# CITY OF ALBUQUERQUE

**RE: Main Event, Albuquerque Carpenters Training Center (File: G16-D149)**  
**4040 Pan American Freeway NE 87107**  
**Grading Plan and Drainage Plan, Engineer's Stamp Date 5-14-2015**  
**Engineer's Certification Dated 5-19-16 sheet C5 only**

Based on the Certification received 5/19/2016, the site is acceptable for a TEMPORARY 30-day Certificate of Occupancy by Hydrology.

MAIN EVENT		DRAWN BY
PAN AM FREEWAY AND VASSAR AV.		BJF
GRADING PLAN		DATE
		05/14/15
		2015015-GRB
		SHEET #
<b>TIERRA WEST, LLC</b> 5571 MIDWAY PARK PLACE NE ALBUQUERQUE, NM 87109 (505) 858-3100 www.tierrawestllc.com		<b>C5</b>
		JOB #
		2015015

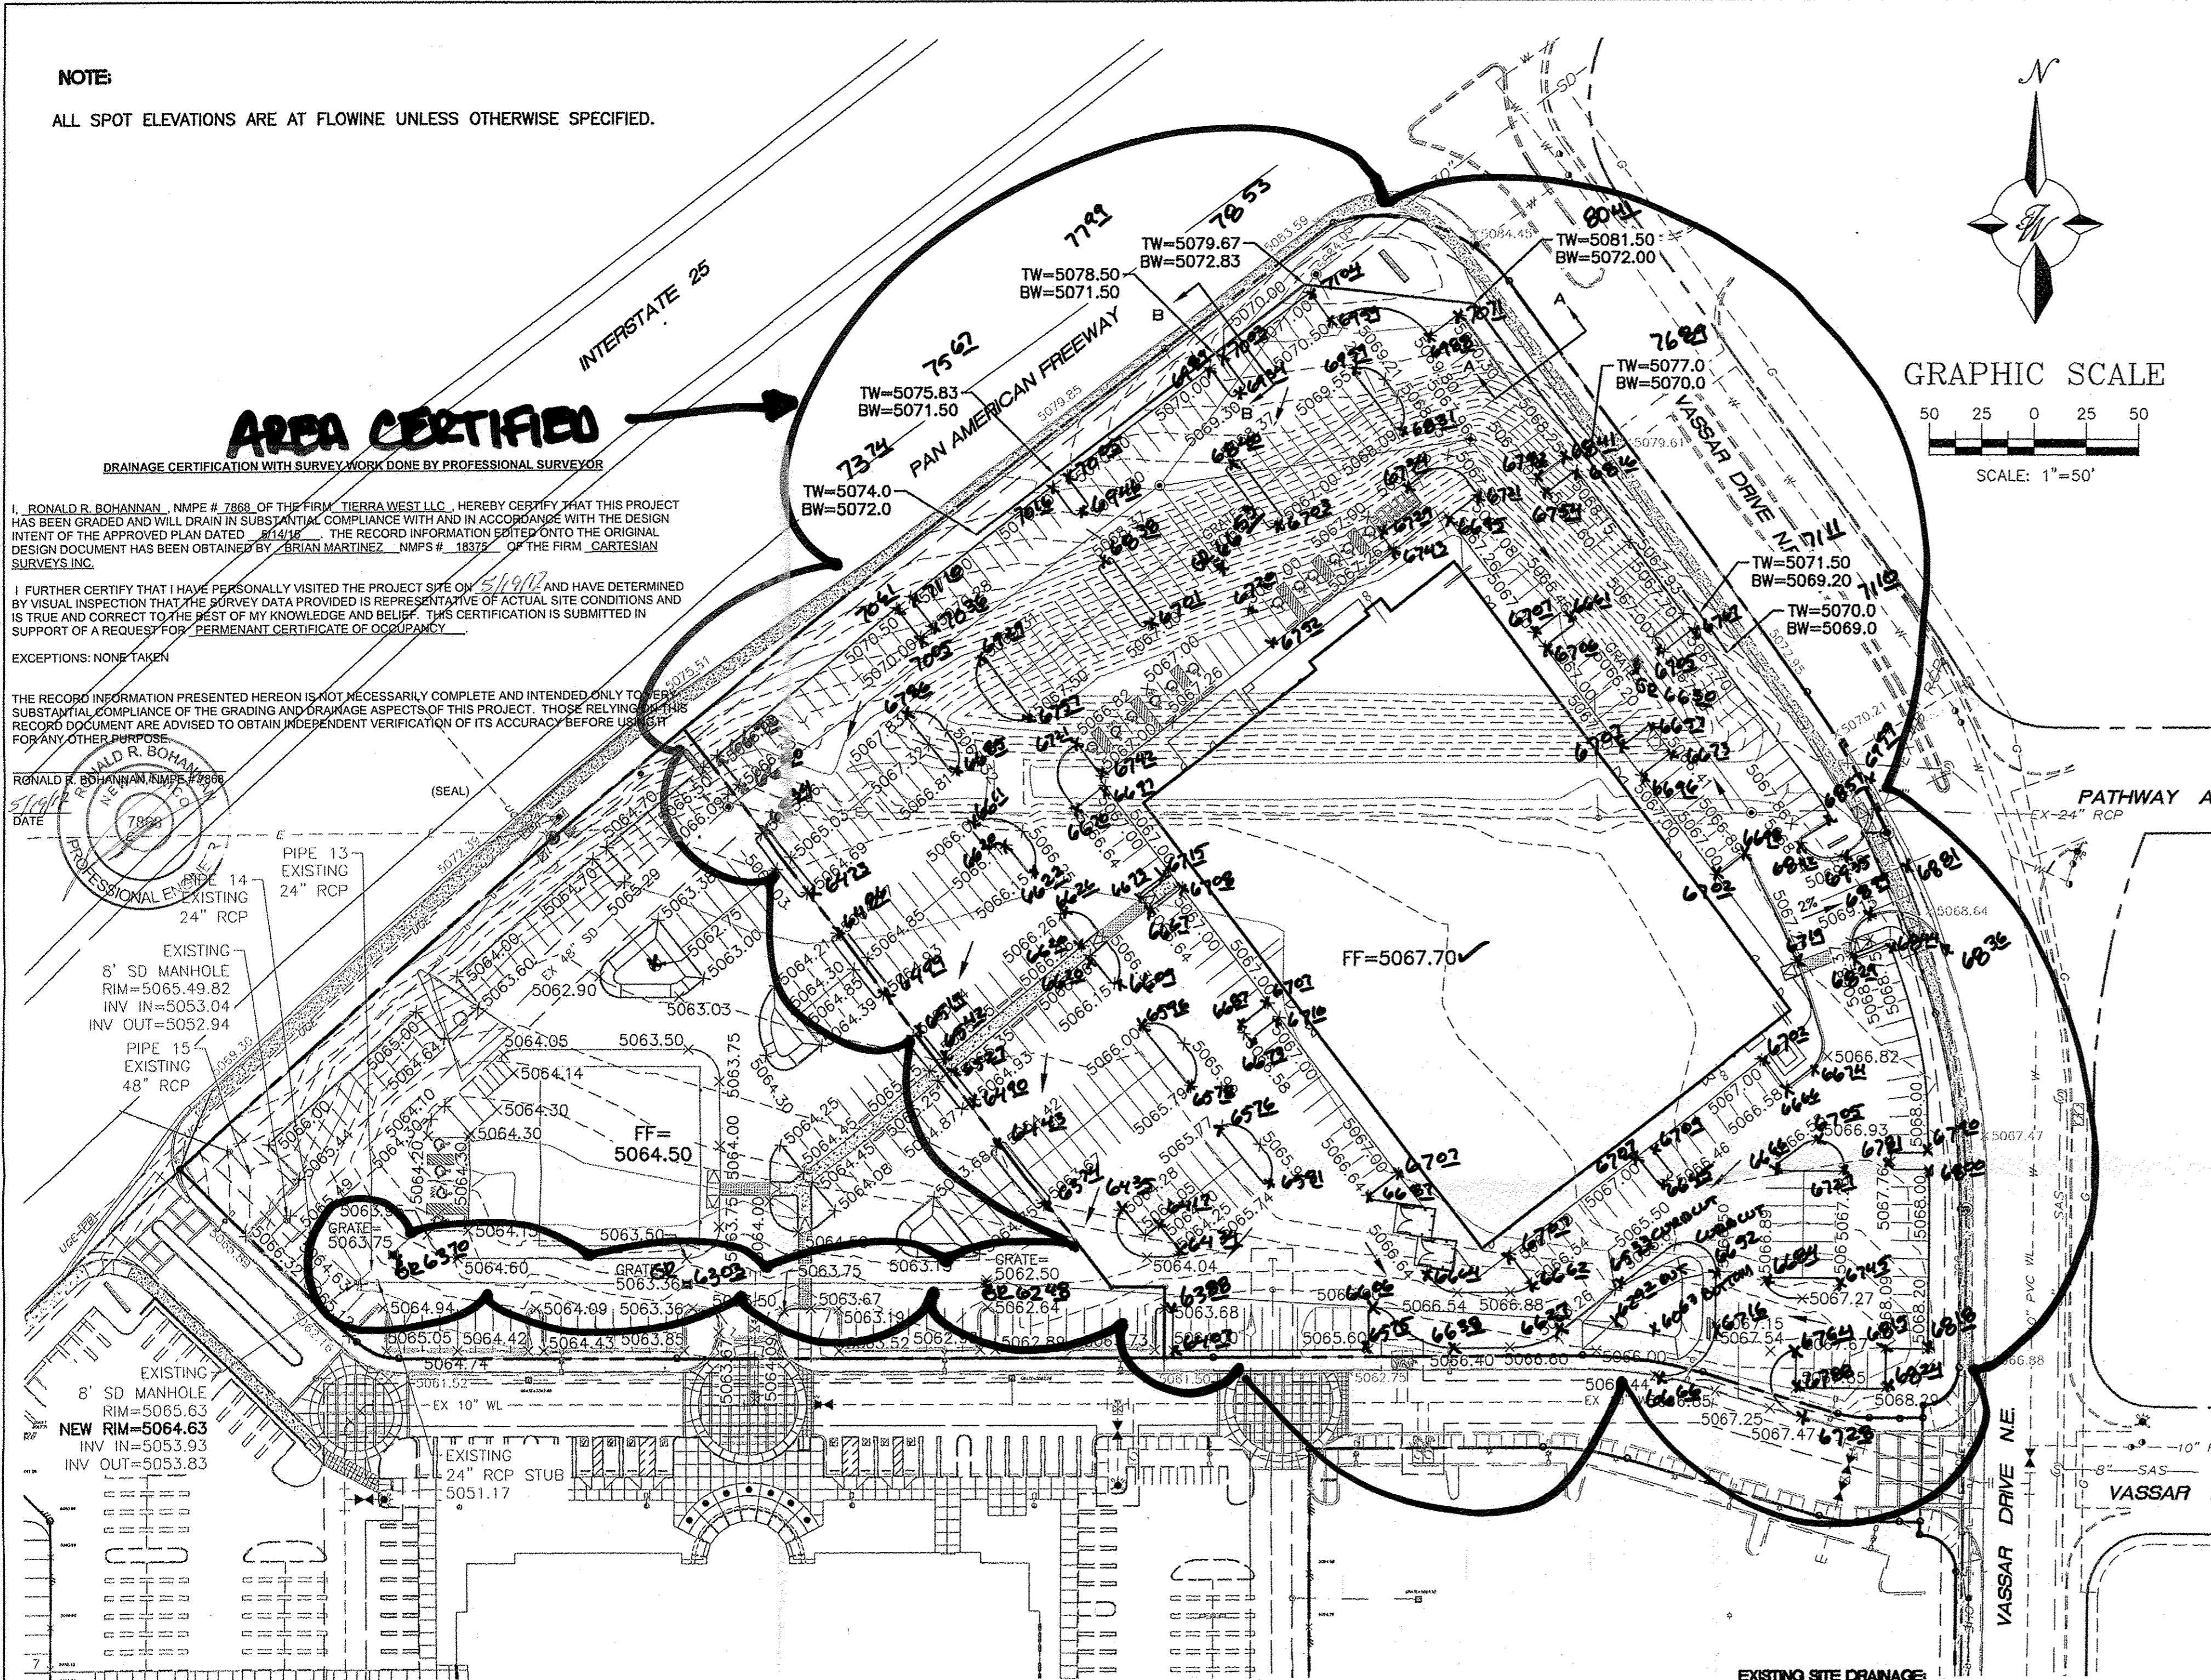
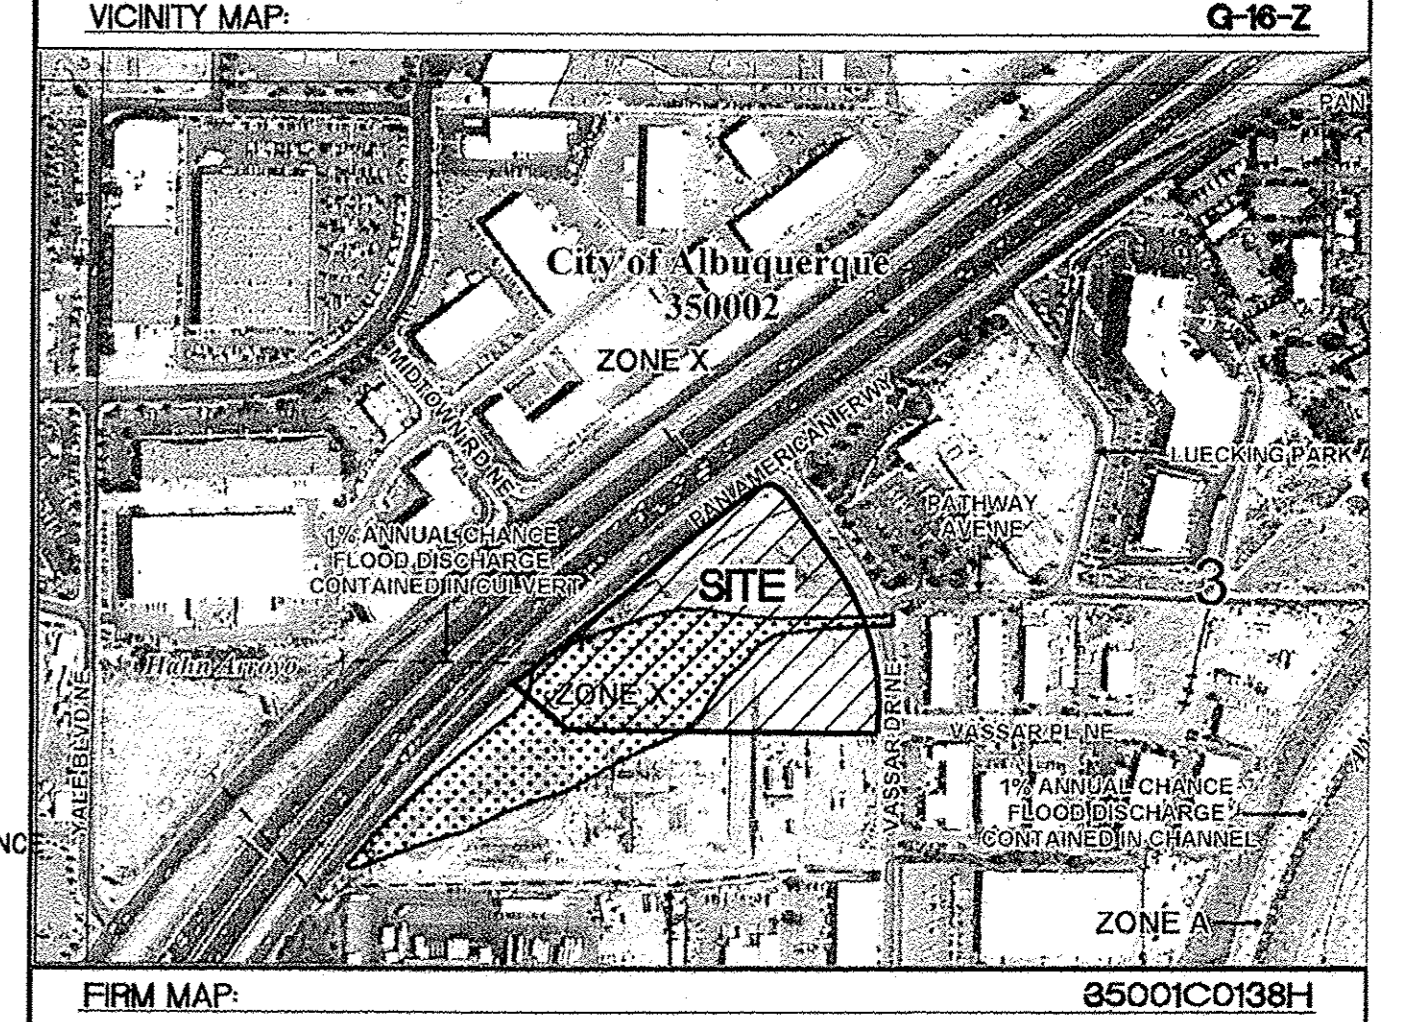
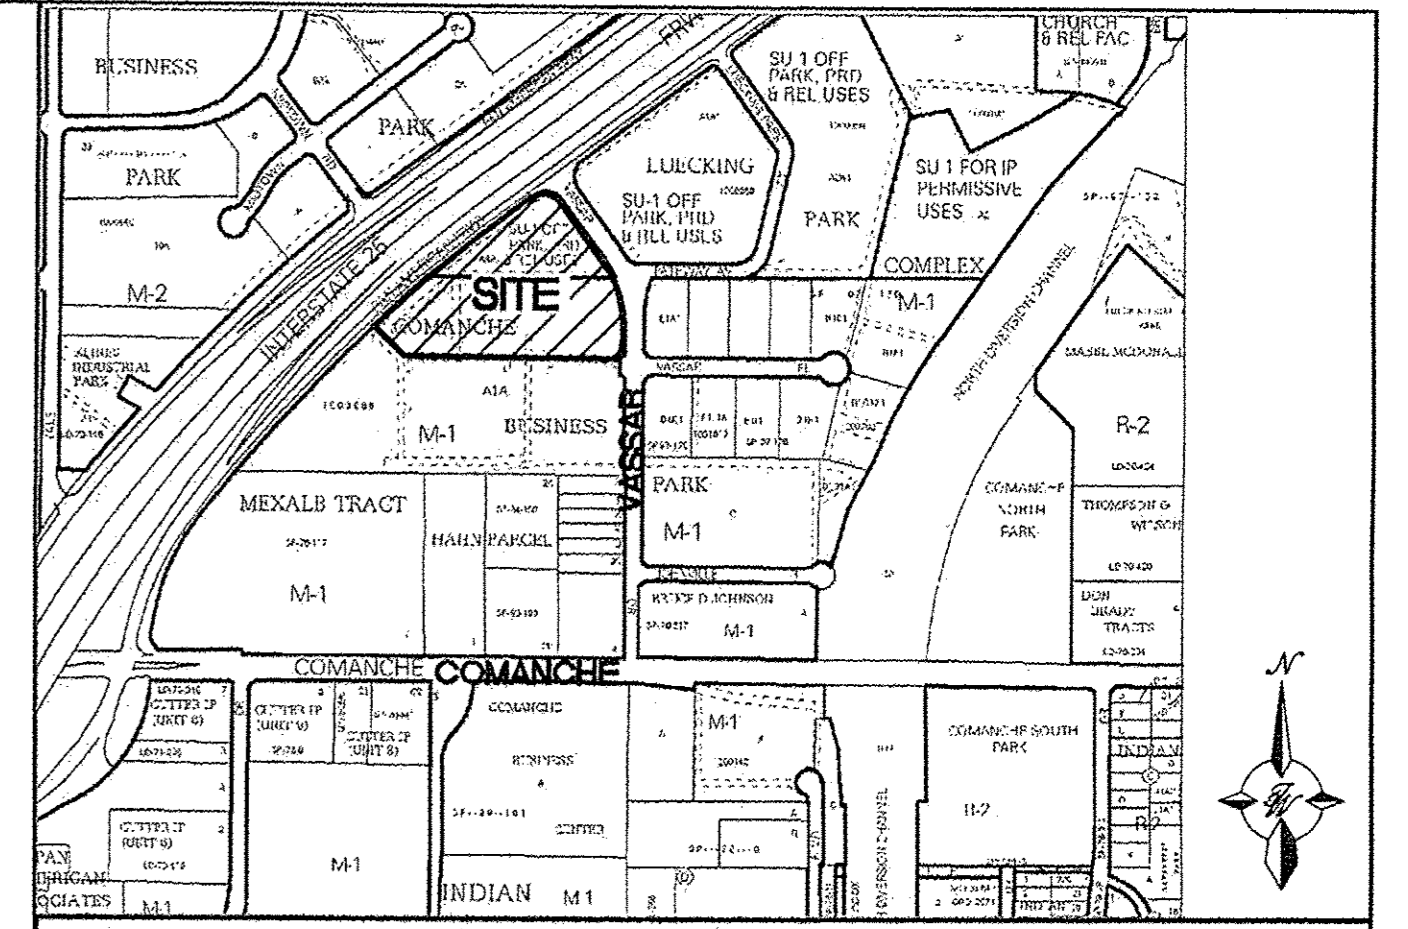
The grading plan that was approved showed two developed lots, with the northern lot draining to the southern lot. The southern lot has not been developed. Since the entire development was intended to be phased, there should have been an "interim" grading plan submitted and approved. The correct procedure is to have the engineer submit an interim grading plan for approval and then have that plan certified. In the future, provide an interim plan if the project is to be phased.
